Sent: 19/04/2021 10:42:46 AM
Subject: DA2020/1351 - 1 Bilambee Lane, Bilgola Plateau
Attachments: Garner NBLPP.docx;

S U B M I S S I O N : G A R N E R
a written submission by way of further objection to DA 2020/1351

Re:
#I Bilambee Lane, Bilgola Plateau
DA 2020 1351

WRITTEN SUBMISSION: LETTER OF OBJECTION
Submission: Garner

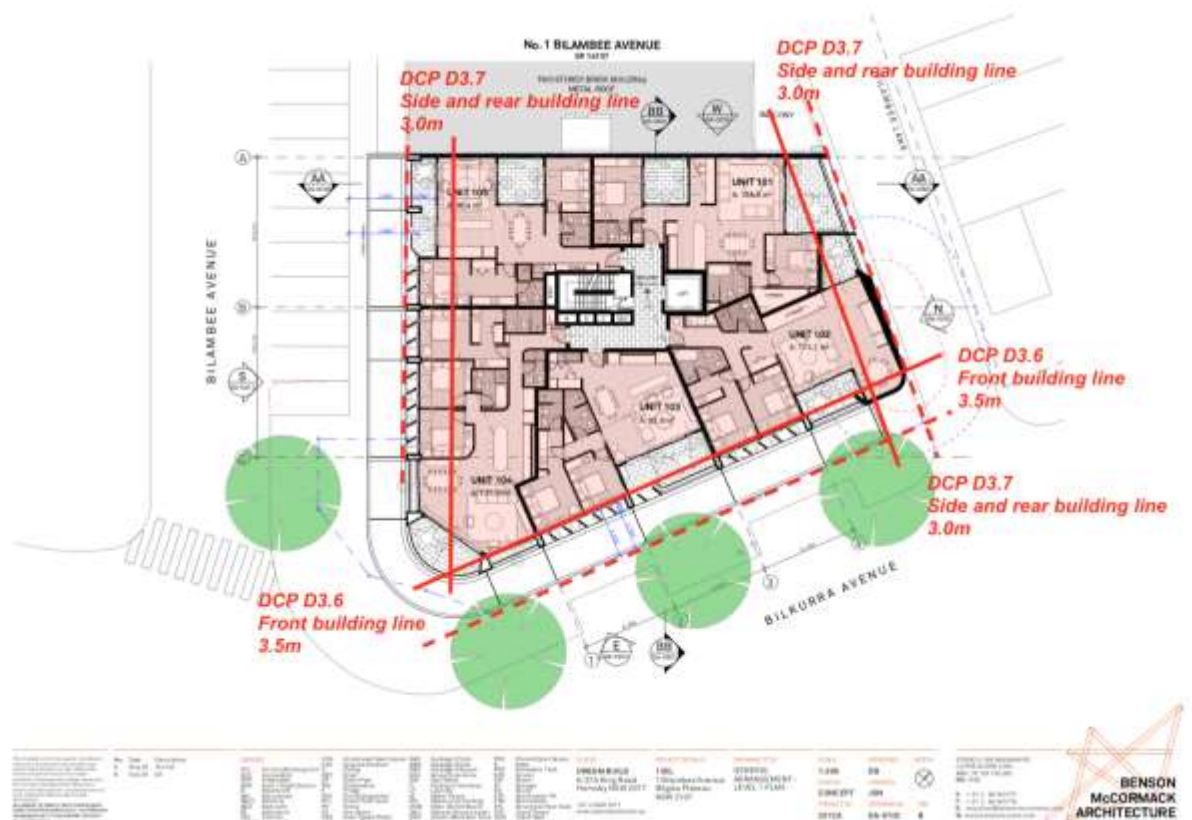
The proposed development will present a massive overdevelopment facing our property – the complete frame would be lost to overdevelopment:

The proposed **8.5m high wall heights** to the lower parapet exceed the existing timber pole, and the proposed **10.0m height to the roof**, and **plant screens to 11.4m** are well above the photograph – it would be a devastating outcome!

The proposed development is *offensive, jarring or unsympathetic* in a streetscape context:

Any redesign must be a two-storey development, with compliant setbacks, with compliant 8.5m height to the top of plant screens.

Decks facing south must have solid balustrades and solid privacy screens to 1.6m height to overcome privacy concerns.
